Your ref: SSD-109645990
File no: MC-26-00003

Request for SEAR's – Parkland Estate, Rouse Hill

RESPONSE TO SEAR's REQUEST – BLACKTOWN CITY COUNCIL

PROJECT: SSD-109645990 – Parkland Estate, Rouse Hill

Figure 57 Long section illustrating the Master Plan in the context of Rouse Hill House

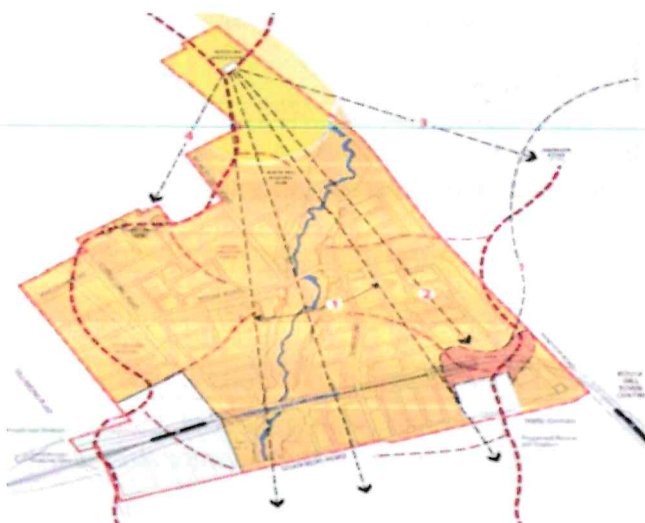
The current proposal, which seeks heights of up to 20 storeys in Stage 3 and 18 storeys in Stages 4 and 5, represents a substantial exceedance of existing height controls, with no clear justification provided, particularly as it is within a view corridor that was identified in a comprehensive Landscape and Visual Analysis of the Rouse Hill Estate, prepared in 2011 by LFA (Pacific) Pty Ltd for the former Department of Planning, to inform the master-planning process. That study identified key view corridors from the Estate, as illustrated in the LFA 2011 plan below.

The subject Planning Proposal will need to be supported by a Landscape and Visual Analysis to address the proposal’s inconsistencies with long-standing expert heritage and planning advice. It is noteworthy that there is a ridgeline and water reservoir between Rouse Hill Estate and the subject site which may provide some visual screening, but it is up to the applicant to demonstrate this.
